UNITED STATES PATENT AND TRADEMARK OFFICE

APPLICATION NO.	FILING DATE	FIRST NAMED INVENTOR	ATTORNEY DOCKET NO.	CONFIRMATION NO.
10/729,204	12/05/2003	Roger Thomas	P-US-PR-1106	2444

Office Action Summary	Application No.		Applicant(s)	
	10/729,204		THOMAS, ROGER	
	Examiner		Art Unit	
	Shelley Self		3725

DETAILED ACTION

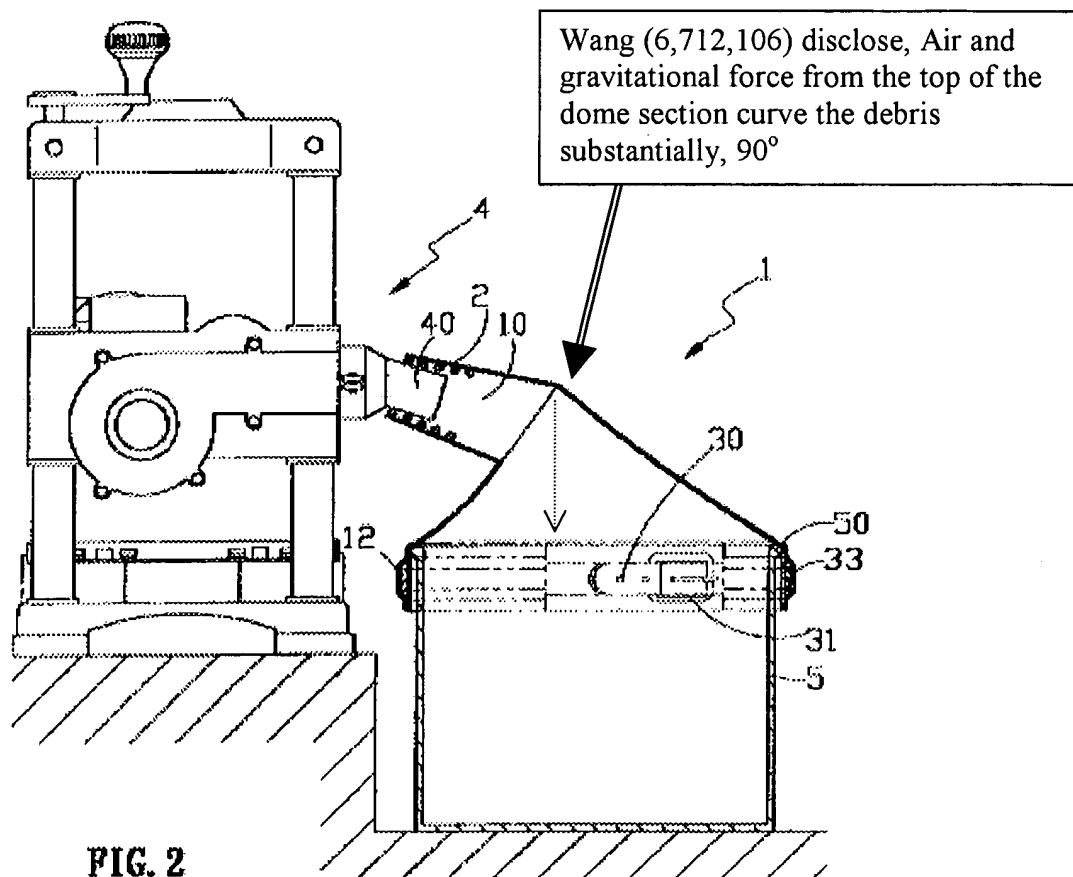
Claims 1-3, 6-10 and 12 as best as can be understood are rejected under 35 U.S.C. 102(e) as being anticipated by Wang (6,712,106). Wang discloses a debris collection container (5) for a planer (fig. 2) which employs a stream of air to remove debris generated by the planer, the debris collection container comprising: a receptacle (5) for storage of the debris; and a connector (fig. 4) attachable between the receptacle (5) and the planer, the connector including a connection section and a part spherical shaped dome section (fig. 4), the connection section attached to a side wall of the part spherical shaped dome section (fig. 4) and defining an aperture through which air and debris pass from the connection section into the part spherical shaped dome section (fig. 2), the part spherical shaped dome section having a base and the base defining a

aperture through which air and debris enter the receptacle (5) and wherein the part spherical shaped dome section includes/acts a deflector for curving the path of air and debris through substantially ninety degrees as the path passes through the part spherical dome section.

Examiner notes, that the debris follows the spherical section (10) to a highest most point, i.e., along a furthest wall of the spherical section and fall by air and gravitational force downward, i.e. at 90 degrees (fig. 2).
